Section : Wind Noise
 Squeak / Rattle
 Ref. No. : WS-1001
 Date : August 2001
 Page : 1 of 2

Model Name: PRIUS

Subject: SQUEAK NOISE FROM FRONT SEAT TRACK

Production Countermeasure

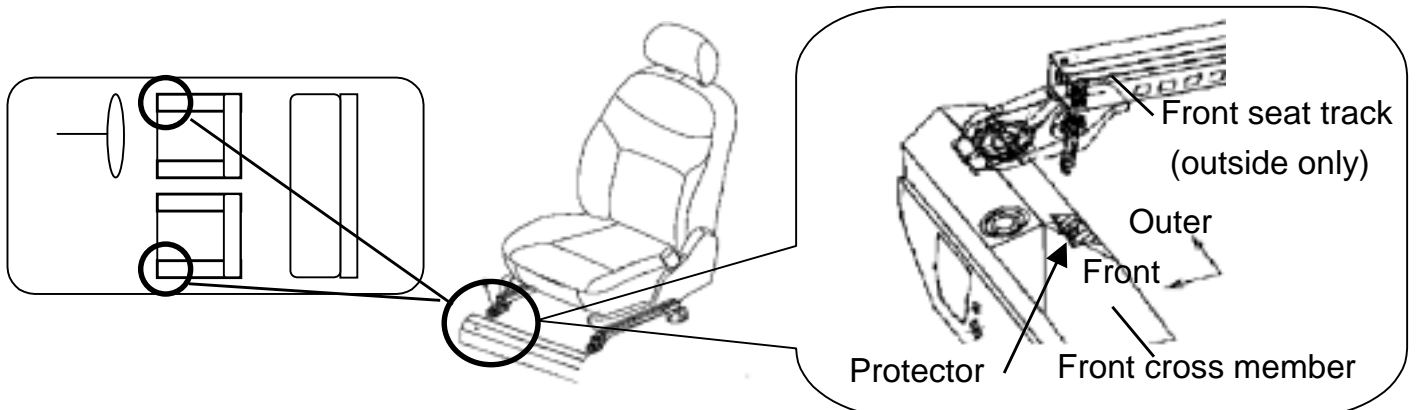
Material of protectors which are installed between front seat tracks (outside only) and front cross member as shown below has been changed from felt to film tape to prevent the squeak noise.

Remove the original protector (felt) and stick a new protector (film tape) on the front cross member as shown below (outside seat tracks only).
